# UNITED STATES PATENT AND TRADEMARK OFFICE

APPLICATION NO.	FILING DATE	FIRST NAMED INVENTOR	ATTORNEY DOCKET NO.	CONFIRMATION NO.
10/016,054	12/06/2001	David J. Nelson	83186WRZ	4831

<b>Office Action Summary</b>	<b>Application No.</b>	<b>Applicant(s)</b> <span style="float: right;">AK</span>	
	10/016,054	NELSON ET AL.	
	<b>Examiner</b>	<b>Art Unit</b>	
	Leonard S. Liang	2853

## DETAILED ACTION

FIG. 1

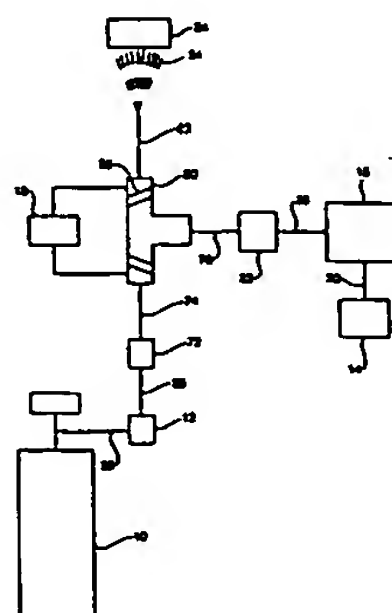
- {claim 1} A printhead for delivering a solvent free marking material to a receiver (fig 3, ref 52 ; column 4, lines 7-9); a discharge device having an inlet and an outlet, a portion of the discharge device defining a delivery path, a portion of the discharge device being adapted to be releasably connected to a single pressurized source of a thermodynamically metastable mixture of a fluid and a marking material at the inlet, the discharge device being configured to produce a shaped beam of the marking material, the fluid being in a gaseous state at a location

beyond the outlet of the discharge device (figure 1, reference 20, 22; column 4, lines 27-28; column 11, lines 44-67; column 12, lines 15-36)

- {claim 10} a predetermined amount of a marking material and a supercritical fluid in a thermodynamically stable mixture, wherein the canister is releasably connectable to a discharge device (figure 1, reference 20)

- {claim 11} A printing apparatus comprising a single pressurized source of a thermodynamically metastable mixture of a fluid and a marking material (figure 1; column 4, lines 27-28); a printhead, portions of the printhead defining a delivery path, the delivery path of the printhead being connected to the single pressurized source, the printhead including a discharge device, the discharge device having an outlet, a portion of the discharge device being positioned along the delivery path, the discharge device being shaped to produce a shaped beam of the marking material, the fluid being in a gaseous state at a location beyond the outlet of the discharge device (figure 1, reference 20, 22; column 4, lines 17-33; column 11, lines 44-67; column 12, lines 15-36)

- {claim 12} a receiver retaining device positioned a predetermined distance from the outlet of the discharge device (figure 1, reference 24)

- {claim 26} a source of fluid connected to the pressurized source (figure 1, reference 10, 14)
- {claim 27} a source of marking material connected to the pressurized source (figure 1, reference 14)

- {claim 28} the pressurized source includes an inlet adapted to receive the marking material (figure 1, reference 30)
- {claim 46} a receiver positioned on a surface of the receiver retaining device (figure 1, reference 24)

Sievers et al further teaches the printhead is rigidly connected to the pressurized source such that the printhead is stationary (figure 1, reference 22).

The applicant's amendments to the claim do not overcome the previous art rejection. While the applicant's arguments seem very reasonable, the examiner does not believe that the addition of the word "single" adequately narrows the scope of the claimed invention to match the applicant's characterization of the invention. The examiner does not see the addition of the word "single" as necessarily meaning that there two sources operable to form fine particles in two steps. Rather, the examiner views the word single in the context of the claimed invention as implying that there's only one pressurized source of a thermodynamically metastable mixture connected to the discharge device. Looking at figure 1, it is clear that Sievers et al discloses this in mixing tee 20; it serves as a single source.

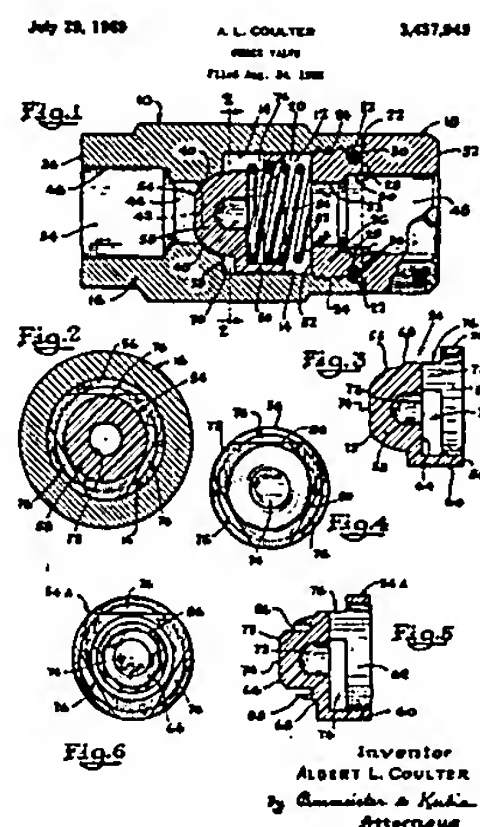
- {claim 1} an actuating mechanism positioned along the delivery path, the actuating mechanism having a first position removed from the delivery path and a second position in the delivery path (figure 1 reference 54)

- {claim 2} the discharge device includes a variable area section (figure 1, reference 40)
- {claim 3} the discharge device includes a constant area section (figure 1, drawn in)

- {claim 4} the discharge device includes a first variable area section connected to one end of a first constant area section, and a second variable area section connected to another end of the first constant area section (figure 1, reference 40; column 1-6)

- {claim 29} the discharge device has a variable area section (figure 1, reference 40)
- {claim 30} the discharge device includes a constant area section (figure 1; drawn in)

- {claim 31} the discharge device includes a first variable area section connected to one end of a first constant area section, and a second variable area section connected to another end of the first constant area section (figure 1, reference 40; column 1-6)

- {claim 32} a second constant area section connected to the second variable area section (figure 1; drawn in)
- {claim 33} the second constant area section having a first predetermined diameter, the second variable area section having a second predetermined diameter, wherein the first predetermined diameter is substantially equal to the

second predetermined diameter (figure 1, reference 40; drawn in second constant area)

- {claim 34} the second predetermined diameter is a maximum diameter of the second variable area section (figure 1, reference 40)
- {claim 35} the first constant area section having a third predetermined diameter, the first variable area section having a fourth predetermined diameter, wherein the third predetermined diameter is substantially equal to the fourth predetermined diameter (figure 1, reference 40; drawn in first constant area)

- {claim 36} the fourth predetermined diameter is a minimum diameter of the first variable area section (figure 1, reference 40; segment both minimum and maximum diameter)

- {claim 39} the first constant area section having a predetermined length, wherein the length of the first constant area section is from about 0.1 to about 10 times the diameter of the first constant area section (figure 1)

- {claim 40} the actuating mechanism includes a position controllable actuating mechanism (figure 1; column 1, lines 12-44)
- {claim 44} the actuating mechanism includes a conical sealing element moveable between the open position and a closed position (figure 1, reference 54)
